Re: Mitigated Negative Declaration (MND) for South Shores Church (SSC) Master Plan (MP)

Comments for
the Notice of Intent
to Prepare a
Draft Environmental
Impact Report
South Shores (Baptist)
Church Master Plan,
SCH NO. 2009041129
submitted by
Robert and Deanna
Saint-Aubin
Monarch Beach 3/22/2010

Re: South Shores Church Proposed Master Plan

FIGURE 4.3.2

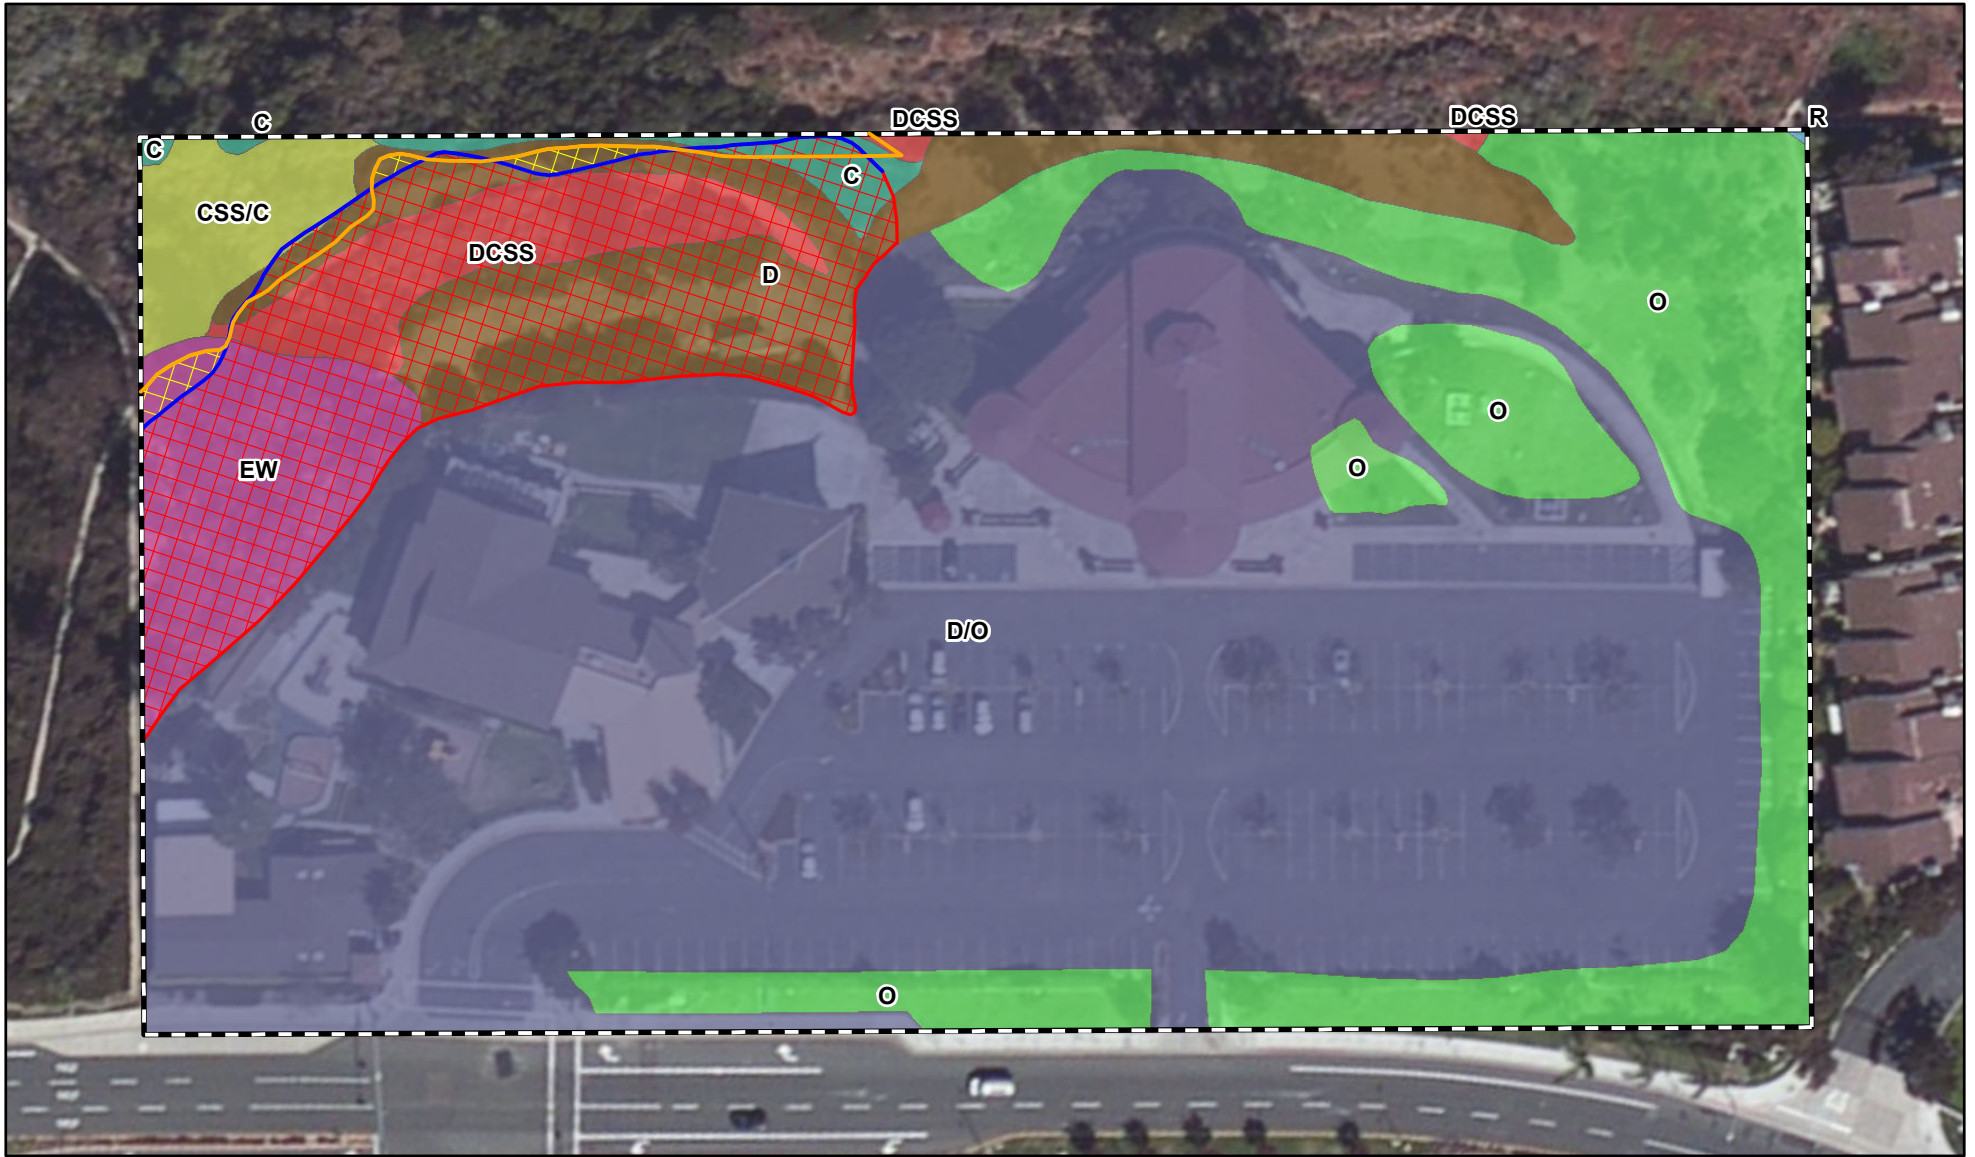
The first paragraph on page 4.3-9 in Section 4.3, Biological Resources, has been revised to refer to a new figure that illustrates the boundaries of the proposed project's coastal sage scrub impacts and fuel modification zones and clarify that fuel modification activities would not affect any areas of coastal sage scrub or chaparral that are not already subject to fuel modification. This revision clarifies the proposed project's impacts on biological resources and has no effect on the analysis or conclusions contained in the Draft EIR.

The proposed project would result in the preservation of 0.12 ac of undisturbed coastal sage scrub and chaparral and the removal of approximately 0.18 ac of disturbed coastal sage scrub and chaparral (see Figure 4.3.4~~2~~), which are each sensitive habitat types covered under the Orange County Central and Coastal NCCP/HCP. According to the Preliminary Fire Master Plan submitted to the OCFA, the proposed project would not result in fuel modification activities within the 0.12 ac of undisturbed coastal sage scrub and chaparral preserved as part of the project.

FIGURE 5.17

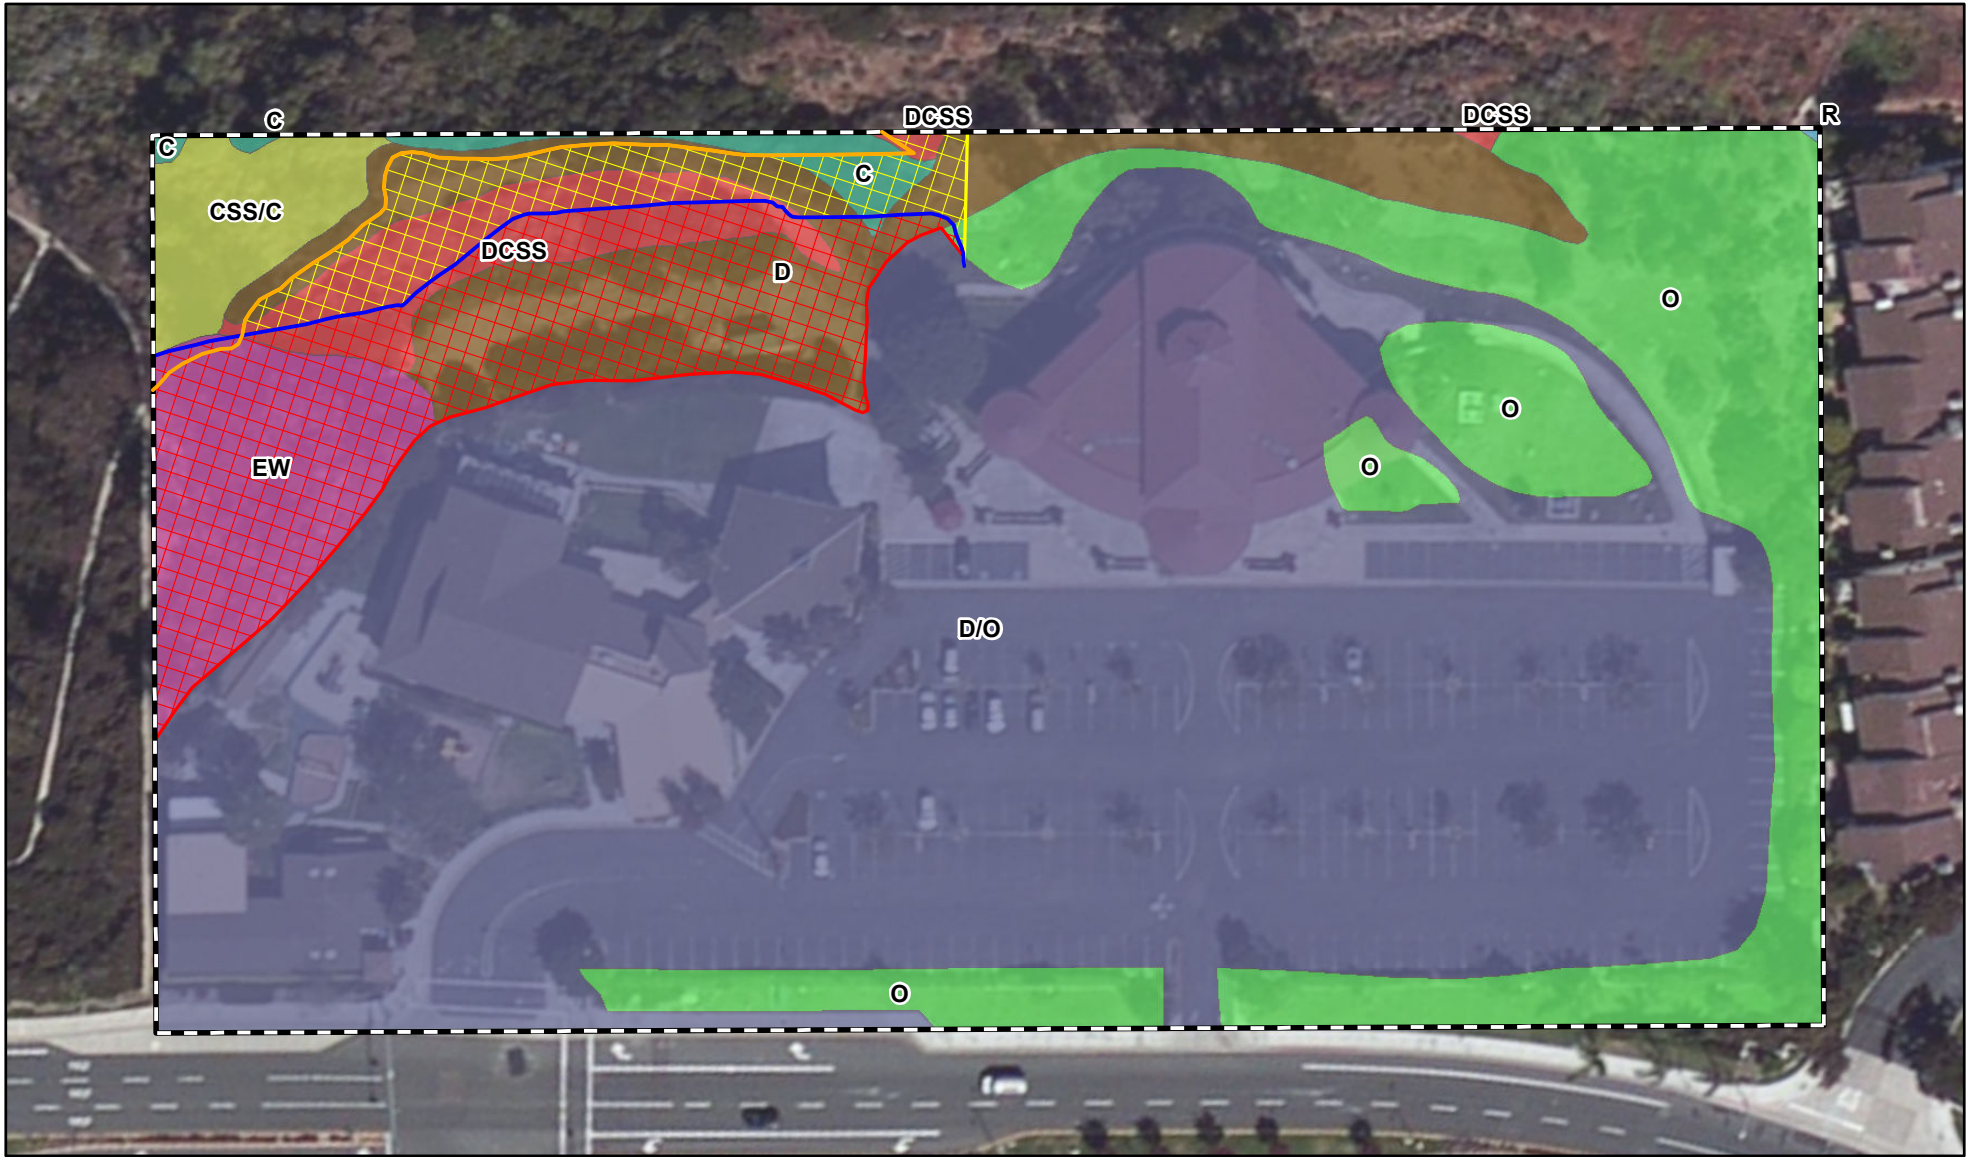
In addition, Mitigation Measure 4.3.1 on page 5-22 in Chapter 5.0, Alternatives, has been revised to include a requirement for submitting a letter report documenting the acreage of coastal sage scrub impacts and fee calculation with provision of the fee to the Nature Reserve of Orange County. The revision also clarifies that a copy of this documentation shall be provided to the CDFW and the USFWS. This revision clarifies the requirements of the mitigation measure and has no effect on the analysis or conclusions contained in the Draft EIR.

Alternative 2, like the proposed project, would preserve 0.12 ac of undisturbed coastal sage scrub and remove approximately 0.18 ac of disturbed coastal sage scrub (see Figure 5.17) in the northeastern portion of the project site. Unlike the proposed project, which would not result in fuel modification activities on any areas of coastal sage scrub or chaparral that are not already subject to fuel modification activities, Alternative 2 would result in fuel modification activities on approximately 0.02 ac of chaparral that is not currently subject to fuel modification activities.
